Access Compliance Report

Public Rights-of-Way

(Curb Ramps)

Intersection ID: 45166	Main Street: ARAGORN_LN	Cross Street: ELESSAR_PL	Location:	N
ADA ID: 714DF8373DF9	Ramp Type: PerpDiag	Initial Pass/Fail: Fail	Overall Compliance: No	Severity Score: 35

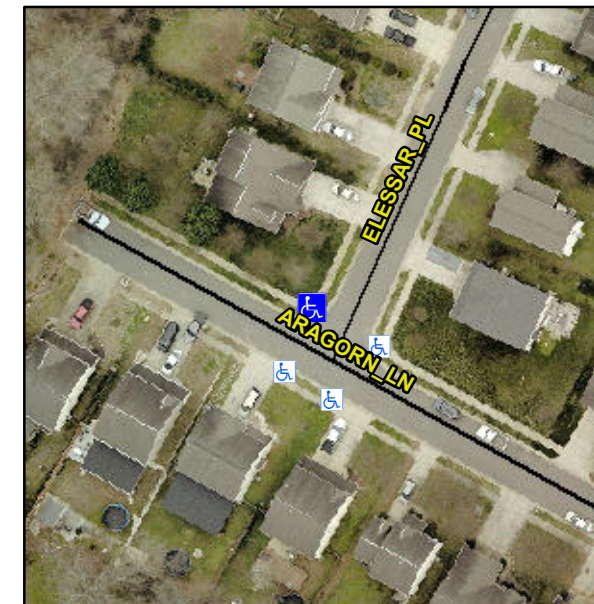
Not Found, R304.5.1, R304.2.2, R304.5.3

Compliance	Description	Data	Compliance	Description	Data
N/A	Ramp Length (in)	46.0	No	Ramp Slope (%)	12.8
No	Ramp Width (in)	41.0	No	Ramp XSlope (%)	3.8
N/A	Flare Type LT	N/A	N/A	Flare Type RT	N/A
N/A	Flare Slope LT (%)	N/A	N/A	Flare Slope RT (%)	N/A
N/A	Flare Traversable LT?	N/A	N/A	Flare Traversable RT?	N/A
N/A	Landing Length (in)	N/A	N/A	DWS Provided?	N/A
N/A	Landing Width (in)	N/A	N/A	DWS Contrast?	N/A
N/A	Landing Slope (%)	N/A	N/A	DWS Length (in)	N/A
N/A	Landing X Slope (%)	N/A	N/A	DWS Full Width?	N/A
N/A	Landing Curb? (Y/N)	N/A	N/A	DWS Offset (in)	N/A
N/A	Shared Landing?	N/A			
N/A	Gutter Ponding?	N/A	N/A	Gutter Slope (%)	N/A
N/A	Gutter Lip Ht (in)	N/A	N/A	Gutter X Slope (%)	N/A
N/A	Painted X Walk1?	No	N/A	Painted X Walk2?	No
	X Walk 1 Direction	To SW		X Walk 2 Direction	To SE
N/A	X Walk 1 Width (in)	N/A	N/A	X Walk 2 Width (in)	N/A
	X Walk 1 Slope (%)	2.3		X Walk 2 Slope (%)	3.4
	X Walk 1 X Slope (%)	4.0		X Walk 2 X Slope (%)	0.6

Remove & Replace Curb Ramp With Two New Directional Ramps or Equivalent.
